# Access Compliance Report

## Public Rights-of-Way

### (Island Curb Cuts)

Intersection ID: 13201	Main Street: REMOUNT_RD	Cross Street: WATSON_DR	Location: N
ADA ID: 95B027E57EE0	Curb Cut Type: MedianRefuge2	Initial Pass/Fail: Fail	Overall Compliance: No
Codes/Mitigation Info/Possible Solution		Field Measurements/Component Compliance

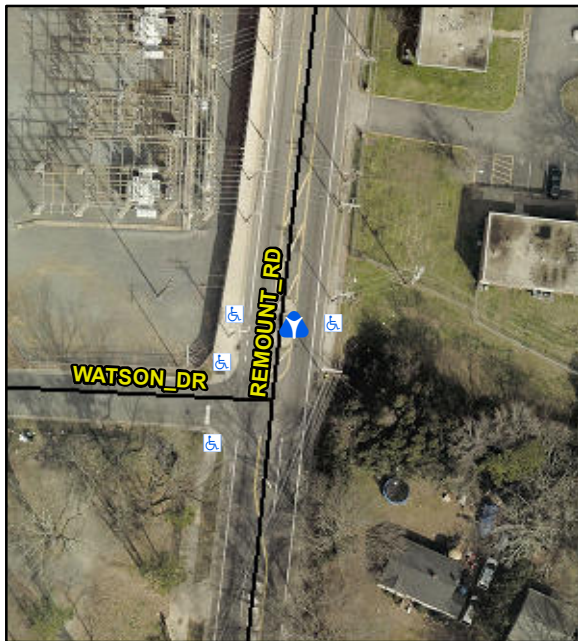
Compliance	Description	Data	Compliance	Description	Data
Yes	Refuge 1 Length (In)	54.0	N/A	Gutter 1 Ponding?	N/A
Yes	Refuge 1 Width (In)	96.0	N/A	Gutter 1 Lip Ht (In)	N/A
Yes	Refuge 1 Slope (%)	0.6	N/A	Gutter 1 Slope (%)	N/A
Yes	Refuge 1 X Slope (%)	4.5	N/A	Gutter 1 X Slope (%)	N/A
N/A	Painted X Walk1?	No	N/A	DWS 1 Provided?	N/A
N/A	X Walk 1 Direction	To W	N/A	DWS 1 Contrast?	N/A
N/A	X Walk 1 Width (In)	N/A	N/A	DWS 1 Length (In)	N/A
N/A	Road 1 Slope (%)	3.6	N/A	DWS 1 Full Width?	N/A
N/A	Road 1 X Slope (%)	3.7	N/A	DWS 1 Offset (In)	N/A
Yes	Refuge 2 Length (In)	53.0	N/A	Gutter 2 Ponding?	N/A
Yes	Refuge 2 Width (In)	96.0	N/A	Gutter 2 Lip Ht (In)	N/A
Yes	Refuge 2 Slope (%)	3.3	N/A	Gutter 2 Slope (%)	N/A
Yes	Refuge 2 X Slope (%)	4.2	N/A	Gutter 2 X Slope (%)	N/A
N/A	Painted X Walk2?	No	N/A	DWS 2 Provided?	N/A
N/A	X Walk 2 Direction	To E	N/A	DWS 2 Contrast?	N/A
N/A	X Walk 2 Width (In)	N/A	N/A	DWS 2 Length (In)	N/A

**Remove & Replace Entire Refuge.**
